CITY OF LOS ANGELES INTER-DEPARTMENTAL CORRESPONDENCE

6650 Franklin Av. DOT Case No. CEN 16-44387

Subject: TRANSPORTATION IMPACT ANALYSIS FOR THE PROPOSED SENIOR APARTMENTS AT 6650 FRANKLIN AVENUE

Attachment 2 Site Plan

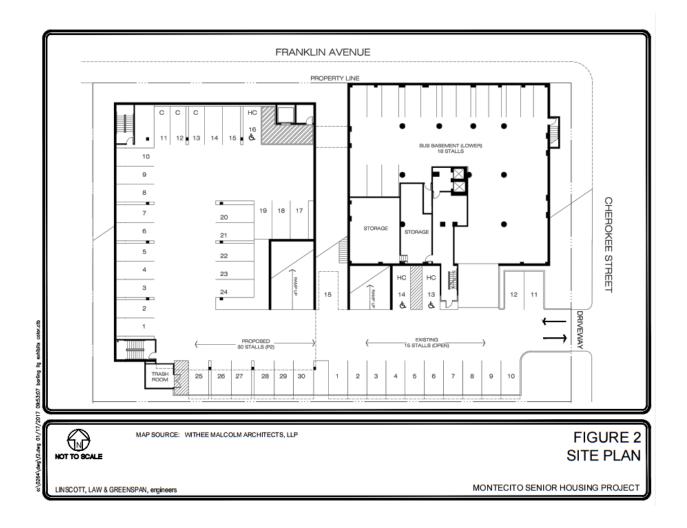
The conceptual site plan for the project (**Attachment 2**) is acceptable to DOT. However, the review of this study does not constitute approval of the dimensions for any new proposed driveways. This requires separate review and approval and should be coordinated with DOT's Citywide Planning Coordination Section (201 N. Figueroa Street, 5th Floor, Room 550, at 213-482-7024). In order to minimize and prevent last minute building design changes, the applicant should contact DOT for driveway width and internal circulation requirements prior to the commencement of building or parking layout design. All new driveways should be Case 2 driveways.
